SUPPLEMENTAL INFORMATION ADDENDUM NO. 1

PROJECT:	ITB No. 18-006 Blue Jay Road Water Main Extension
CONTACT:	Fiona Charleton, Purchasing Agent 912-754-2159 <u>fcharleton@effinghamcounty.org</u>
DATE ISSUED:	April 16, 2018

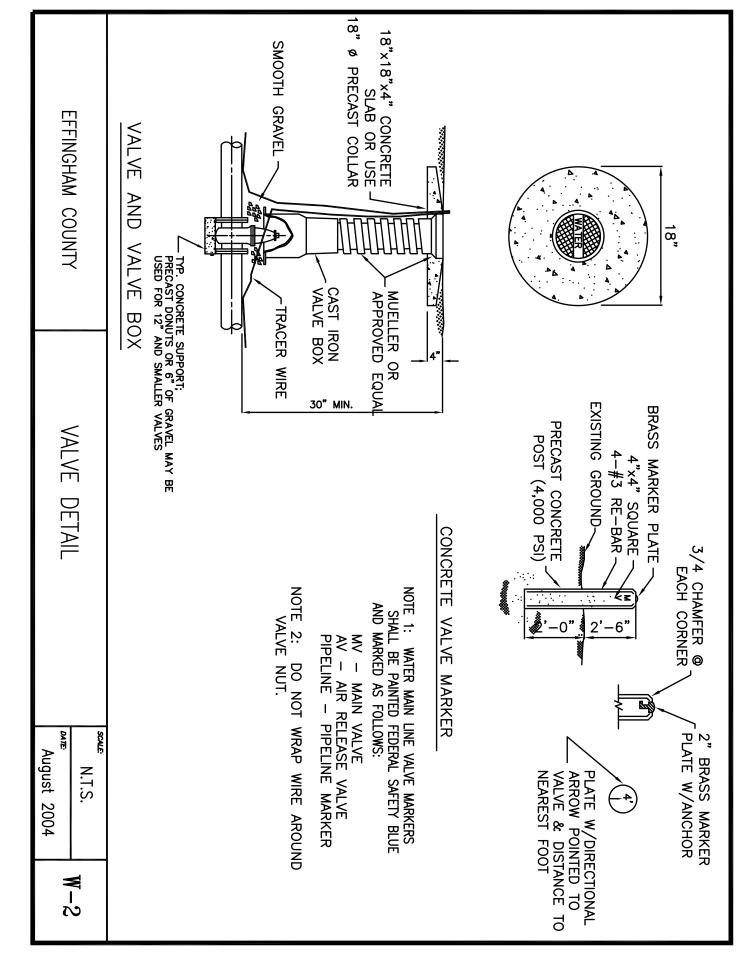
- 3) <u>QUESTION</u>: Bid Items 10 & 11 coordinate with natural gas company and underground telephone conflicts. Measurement and payment states that this item shall cover the cost of relocating the existing telephone and gas utilities as required. As we have no way to determine the extent of the conflicts or the cost of relocations, would you consider changing this to a county determined allowance for use and to cover the cost of any required relocations. Final payment would be for actual cost of relocations plus overhead and profit.

ANSWER: Potential gas conflicts consist of two perpendicular crossings for the proposed water main with existing gas service laterals. In lieu of relocating the gas main, the contractor shall route the water main underneath the gas service laterals using a vertical offset consisting of (four) 45 degree restrained joint bends with (three) joints of restrained pipe upstream of the vertical offset and (three) joints of restrained pipe downstream of the vertical offset. A pay item has been added and the revised bid form is included in this addendum. Measurement will be for each vertical offset. Payment will include labor and materials including the four restrained bends. The restrained joint pipe will be paid for in item 5 (under section III) restrained joint pipe. Pay item #10, "coordinate with natural gas company", will include scheduling with the City of Claxton to be on site when their lines are being crossed. Contractor shall provide at least 1' of separation between the gas service lateral and water main. Regarding telephone conflicts, if the conflict is a perpendicular crossing, the contractor shall provide one foot of separation using vertical offsets if required. If the telephone line is parallel for a potential conflict, then the telephone company must move the line. The contractor will not be responsible for moving the line or paying to move the line. A detail for perpendicular crossing has been included on Sheet 3.

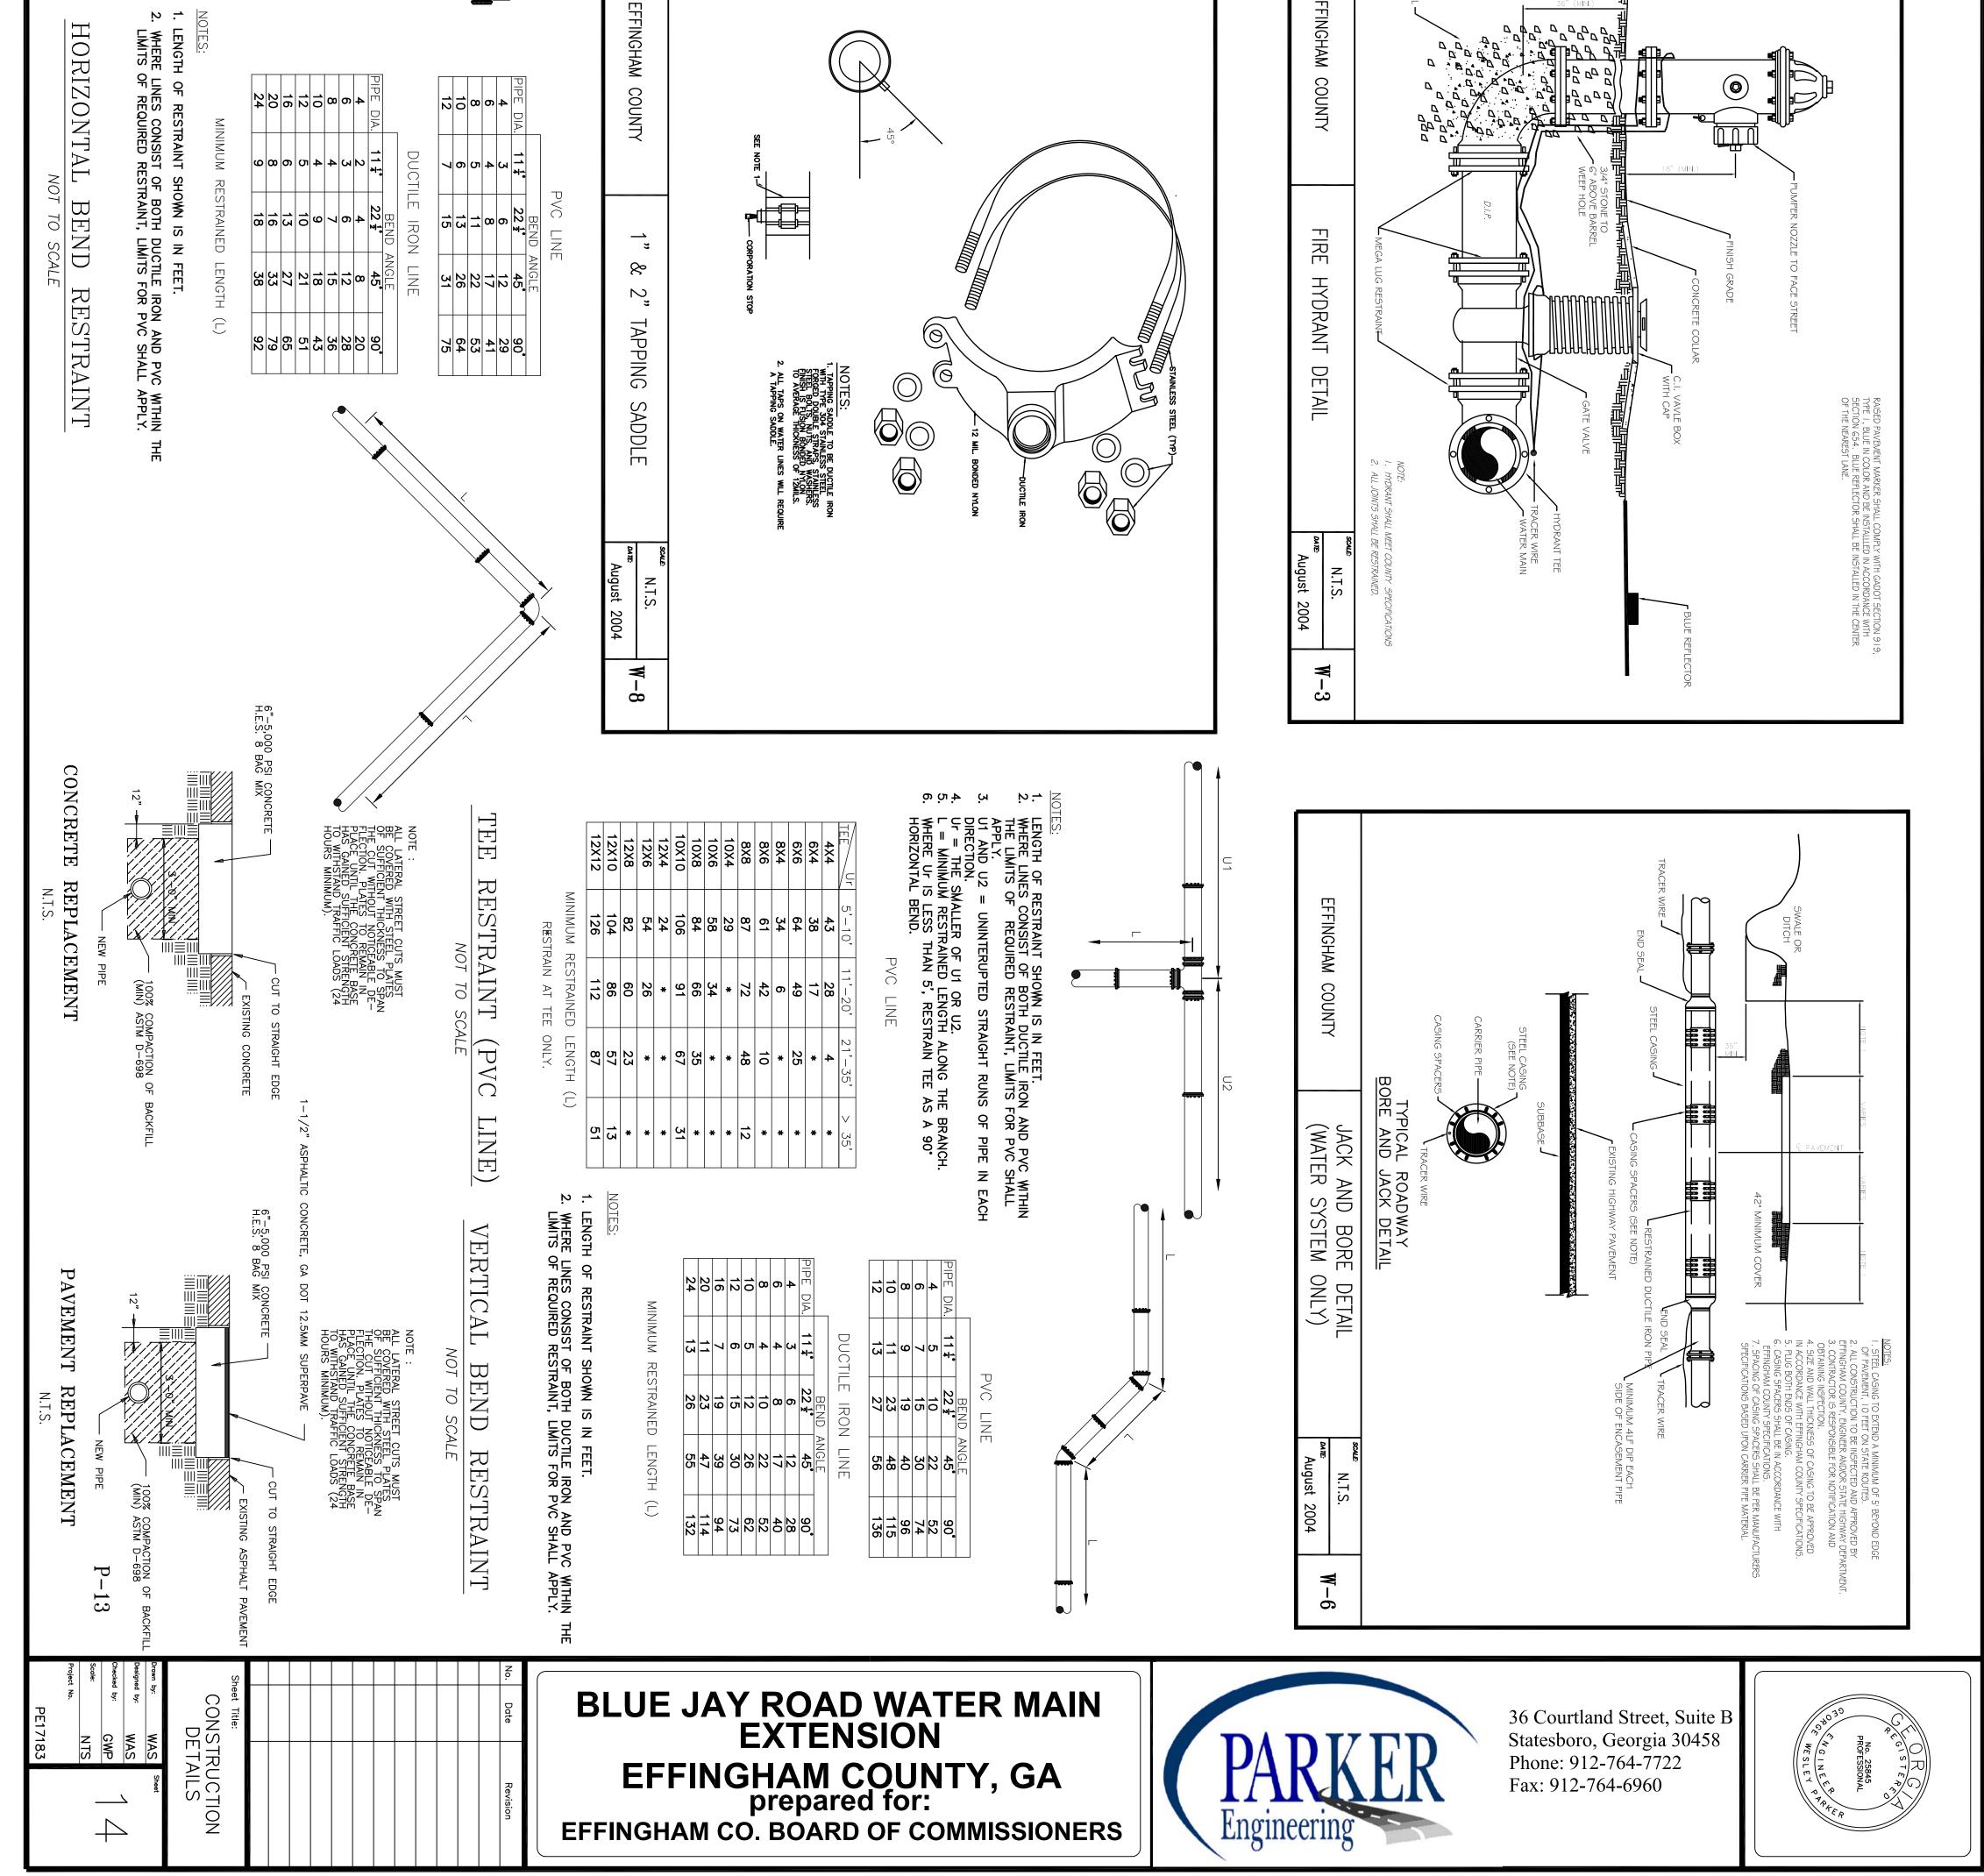
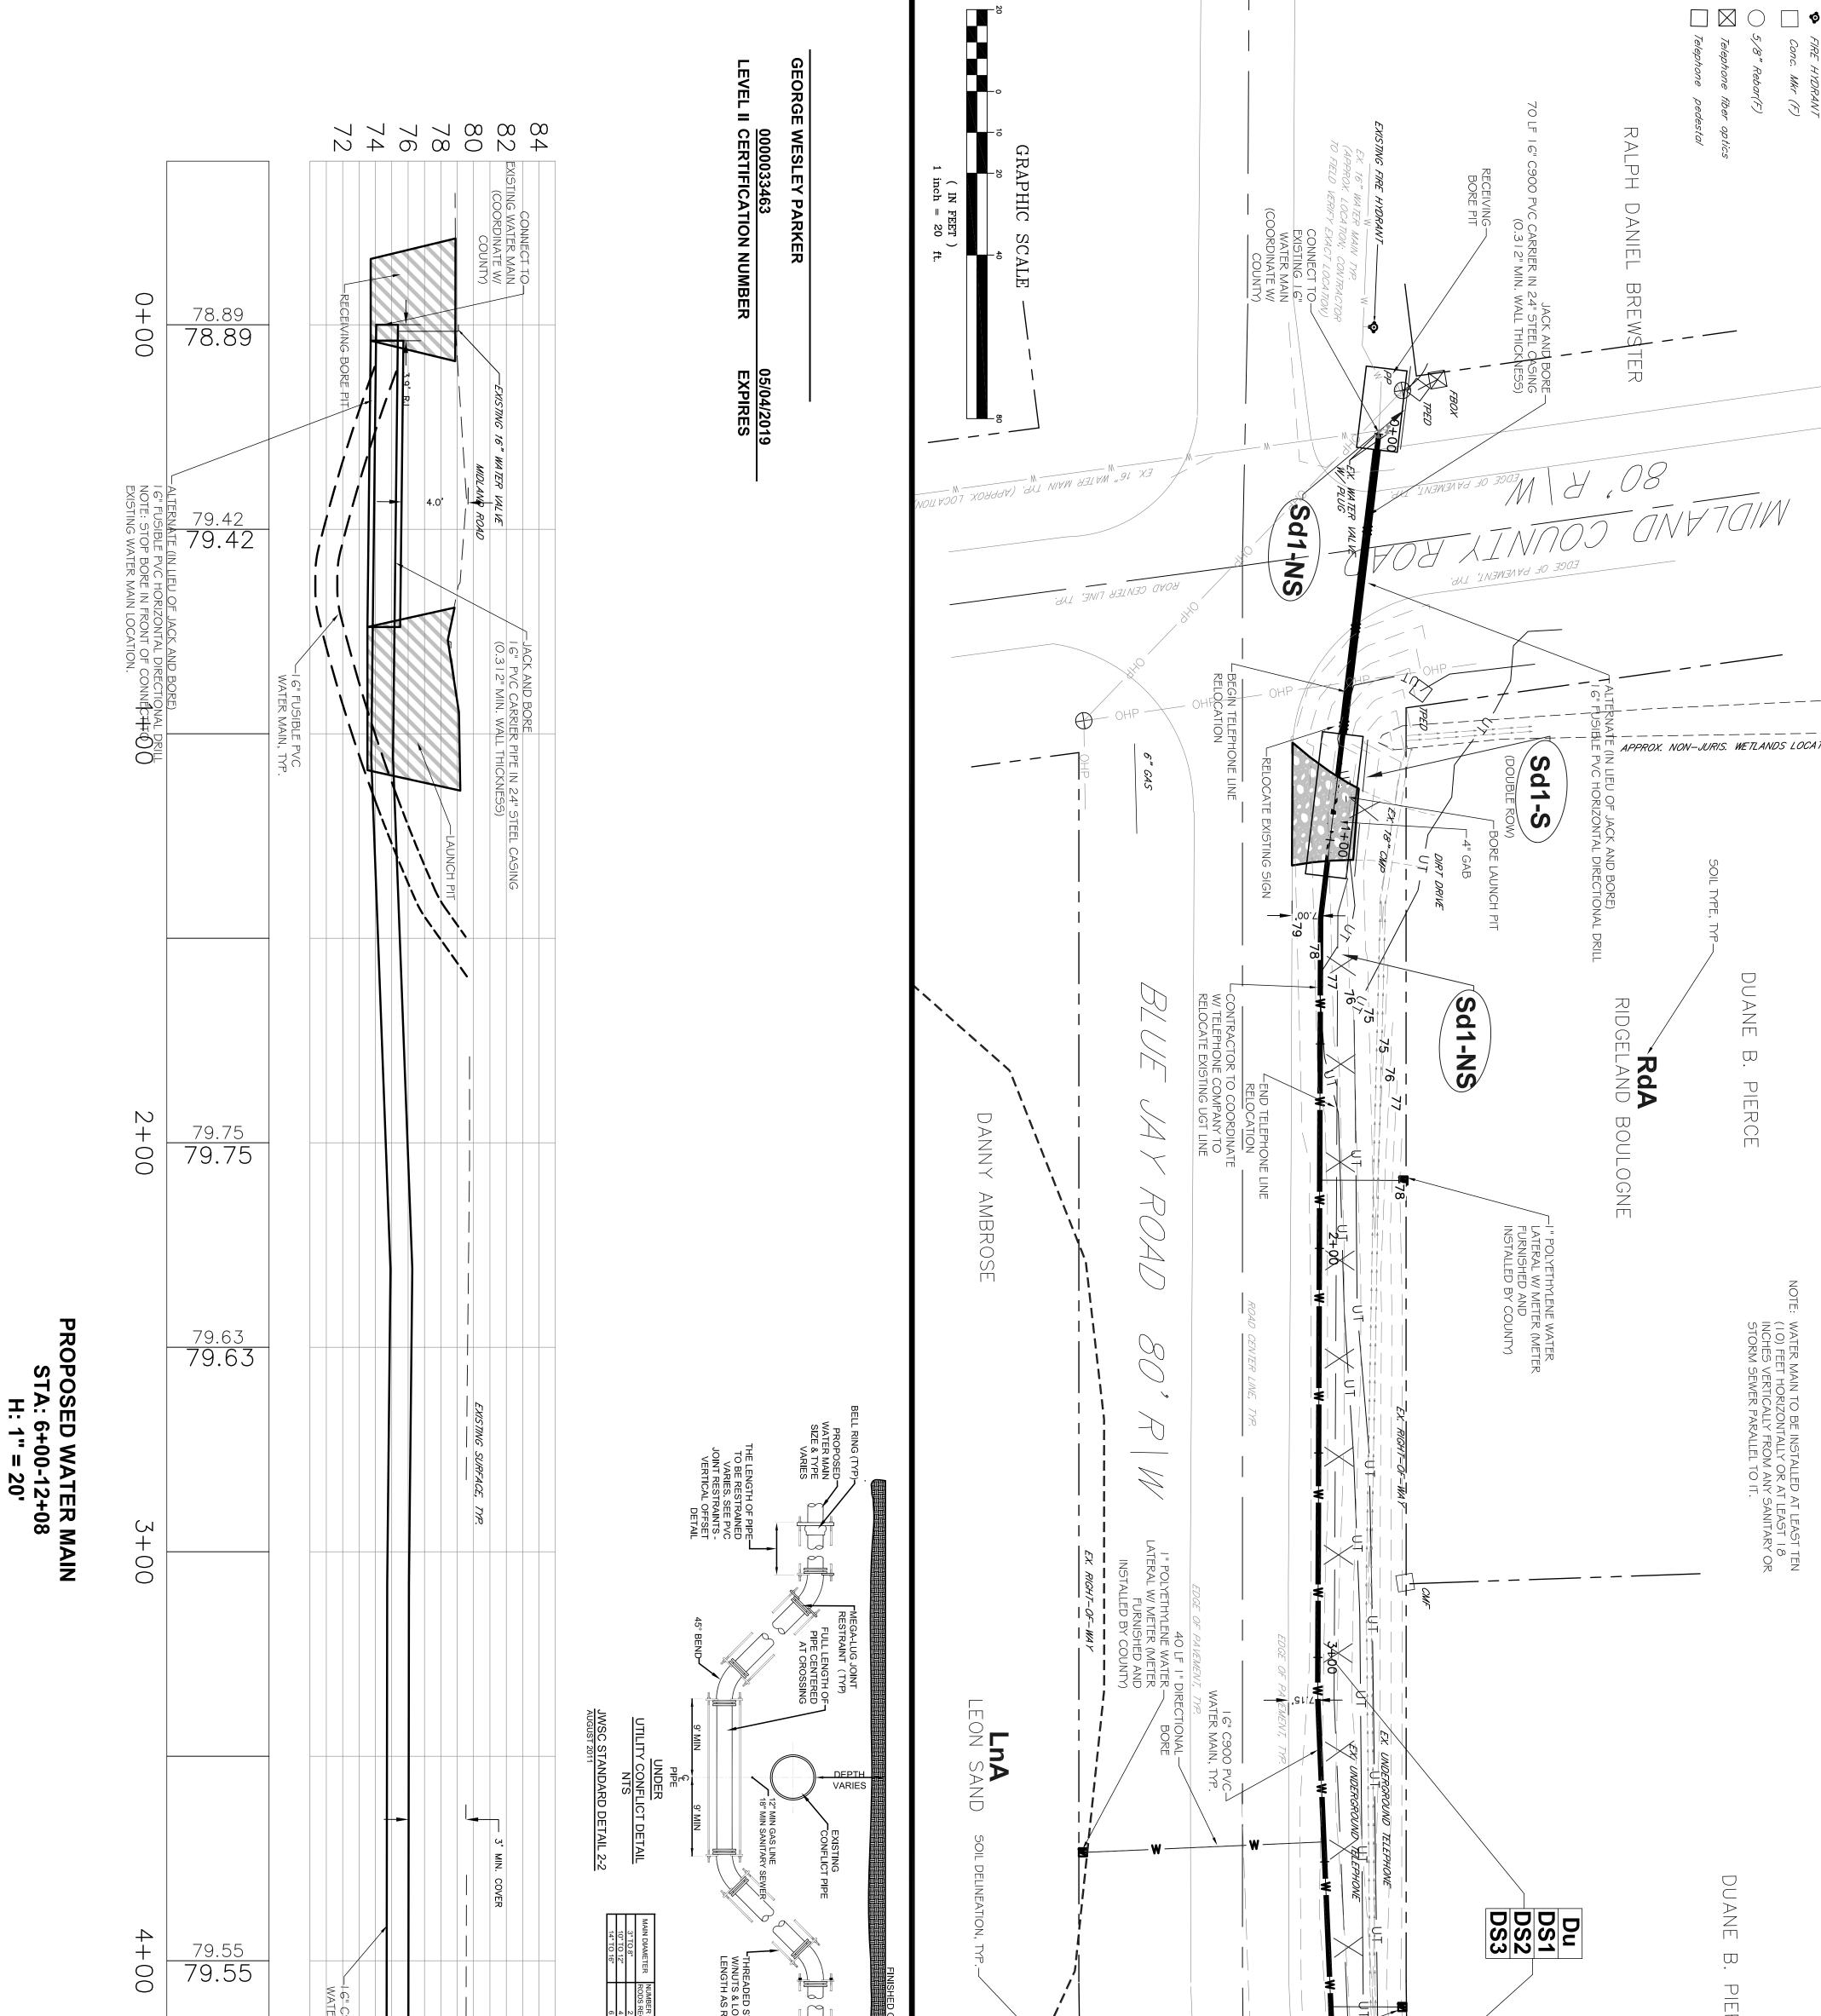
- <u>QUESTION</u>: The location of the Overhead Power appears to be incorrectly shown on plan sheets 3, 4 & 5. Could you please confirm the actual location of the OHP?
 <u>ANSWER</u>: The overhead power location has been shown correctly on sheets 3 and 4, included in this addendum.
